Staff Report & Recommendation

Historic Preservation Board

SUBJECT: HPB19-0341, **1751, 1757 & 1775 Collins Avenue.**

DATE: June 9, 2020

Raleigh Hotel, 2016 Photograph (rooftop additions highlighted in red proposed to be removed)

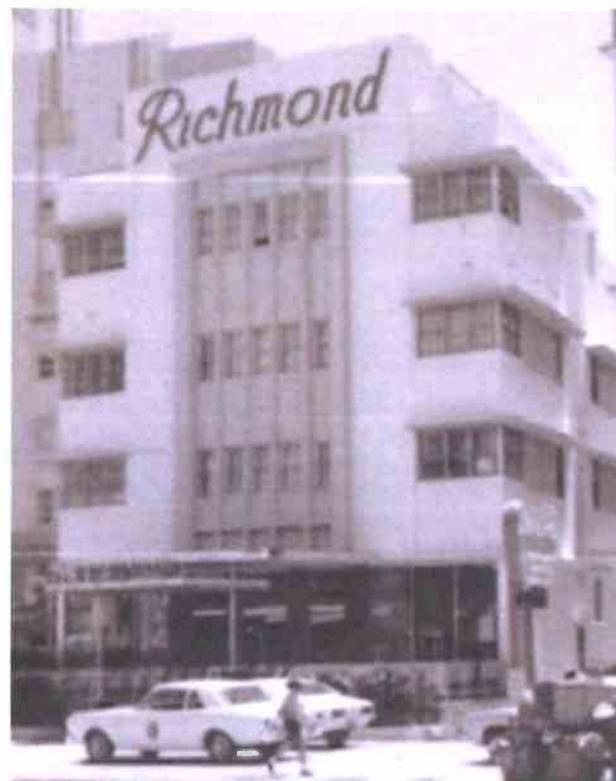
Additionally, as part of this submittal, an expanded scope of restoration is proposed including the removal of several inappropriate rooftop additions (see image below). These rooftop additions have an exceedingly adverse impact on the integrity of the original 1940 Dixon design and their removal will restore the skyline of the Raleigh Hotel to its former grandeur. Other notable restoration includes the reintroduction of a missing window within each set of ribbon windows along the broad curved corner of the building.

Staff is extremely supportive and enthusiastic of the expanded scope of restorative work. This additional scope in conjunction with the previously approved restoration will reposition the Raleigh Hotel as one of the most meticulously restored Streamline style hotels in the world.

- i. Consistent with the proposed plans, the following rooftop additions shall be removed: the 2-story penthouse, the 1-story enclosure at the southwest corner of the building, the 1-story enclosure at the north west corner of the building and a portion of the rooftop addition at the 8th level, in front of the north side of the tower element.

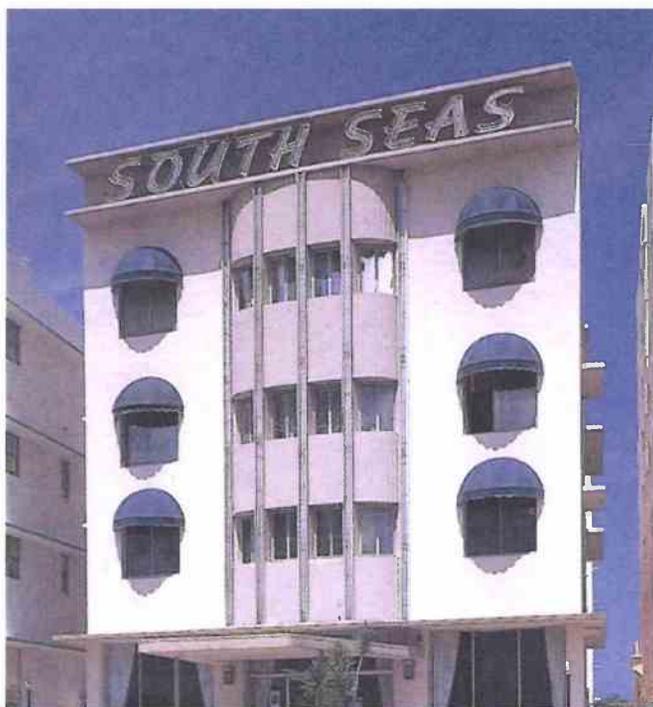
Within the original public lobby, the applicant is proposing to retain and restore significant architectural features including the terrazzo flooring and several presumed Art Deco era fixtures including the elevator details and lighting elements. Additionally, the applicant is proposing to remove the non-original wood paneling. In combination with the restoration, the applicant is proposing several alterations to the lobby including the demolition of the lobby ceiling and second floor slab creating a double-height space. Staff would note that the existing ceiling contains no significant architectural features and the applicant is proposing to introduce a lighting ledge around the perimeter of the lobby, demarcating the location of the original ceiling.
